Security of Supply Forecasting and Information Policy Review

Meridian appreciates the opportunity to provide feedback on the System Operator's consultation paper 'Security of Supply Forecasting and Information Policy (SOSFIP) Review – Draft amendment proposal' (*Consultation Paper*). Meridian's submission is comprised of this letter and an accompanying expert report by Dr Brent Layton, former Chair of the Electricity Authority.

Figure 1: Decadal distributions of Waiau storage

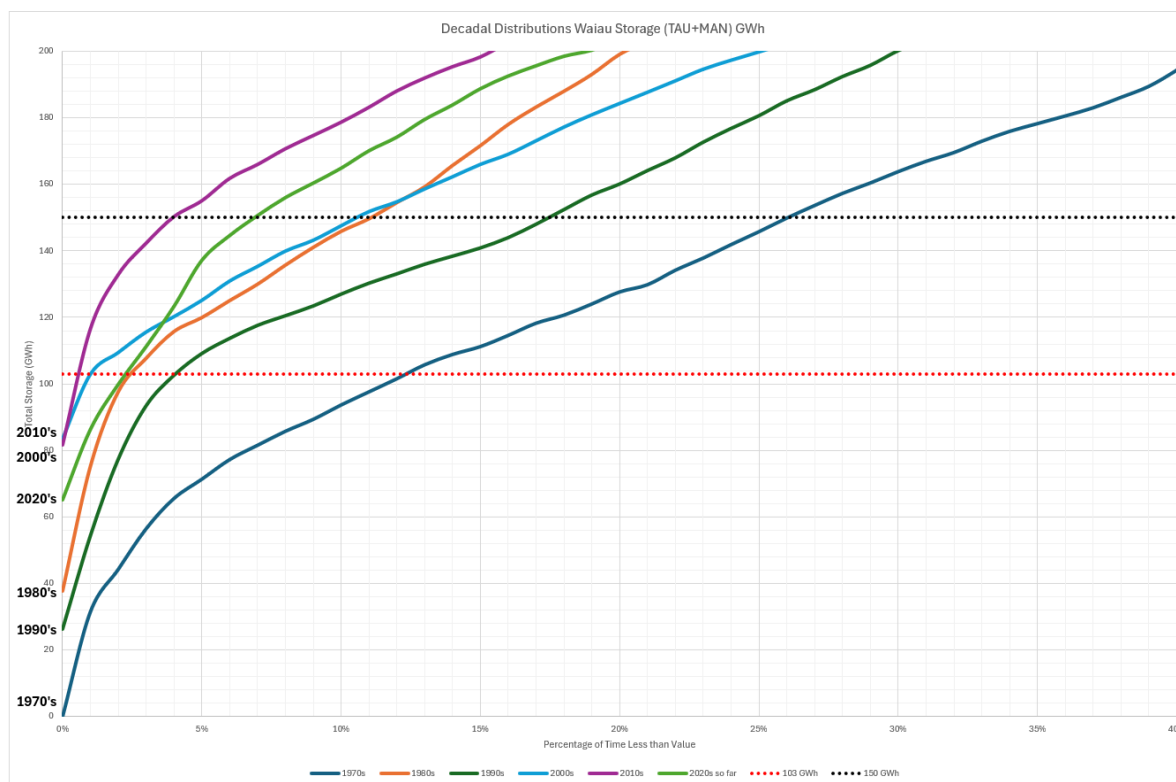
If historical operating levels are to be used as a reference point for setting the buffer, it is important to recognise that operation of these lakes has changed over the last 45 years. To illustrate this, Meridian has analysed the time spent at various storage levels in Lakes Manapouri and Te Anau by decade. The results of this analysis are shown in Figure 1 below.

This analysis makes clear that operation of Lakes Manapouri and Te Anau was quite different between the 1970s and 1990s than between the 2000s and 2020s, with the latter period seeing a much more conservative use of low range storage. This is likely driven by a combination of factors including changes in transmission, load, ownership and portfolios, as well as the creation of the electricity market itself.

If the System Operator chooses to use historical operating levels as a basis for determining an adjustment to the Alert CSRB buffer, it should do so on a forward-looking basis, which would mean only drawing on more recent historical usage patterns which are likely to be more reflective of current and future behaviours. Our view is a buffer adjustment of at least 103 GWh would be more reflective of the recent management of the Waiau lakes and ongoing constraints on operations.

Figure 2: New Zealand ERCs and Simulated Storage Trajectories (SSTs)
Source: Transpower

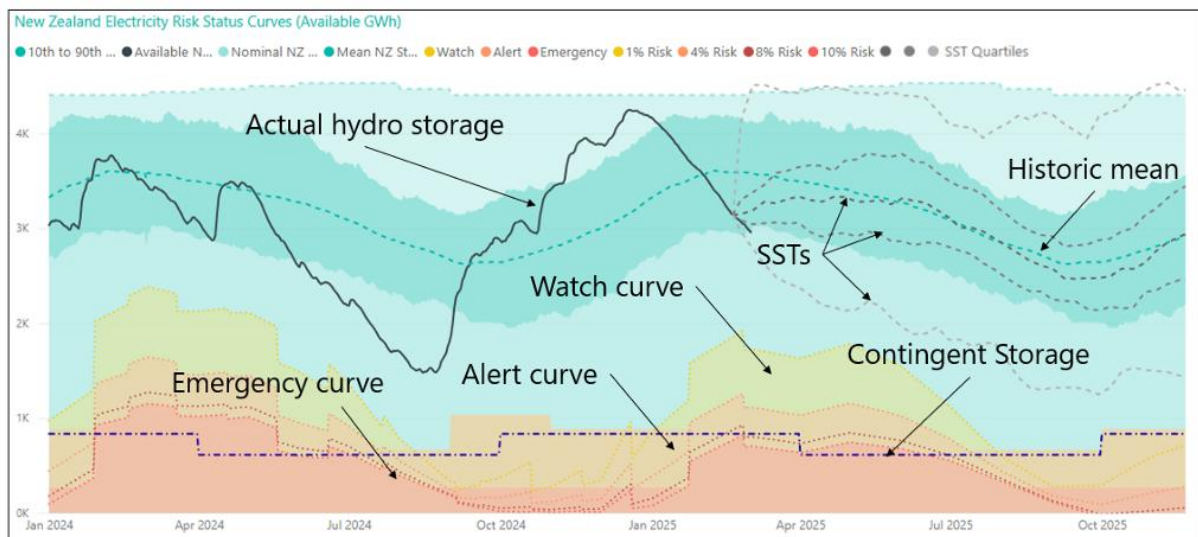
Despite the unusually high prices due to the shortage of water and gas, the requirements to be able to access even the Alert level first tranche of contingent hydro storage as set out in the current SOSFIP did not come close to being met. This can be seen from Figure 2 below.

The Alert level winter contingent reserve of 67 GWh in Lake Hāwea and 331 GWh in Lake Pūkaki would have become available had actual hydro storage in the middle of 2024 crossed into the orange Alert level area but the hydro storage line never got closer than about 700 GWh above it. This occurred around mid-August, at the same time as spot prices peaked.

Figure 2 above, which has been reproduced from a System Operator document, shows that in the 2024 dry year the minimum gap between the Alert CSRB curve and actual hydro storage was 700 GWh and this occurred in mid-winter. Even if 300 GWh had been added to the buffer in 2024, the Alert CSRB would not have been breached by water storage by the order of some 400 GWh. The adjustment the System Operator proposes would not have been effective in providing access to contingent hydro storage.
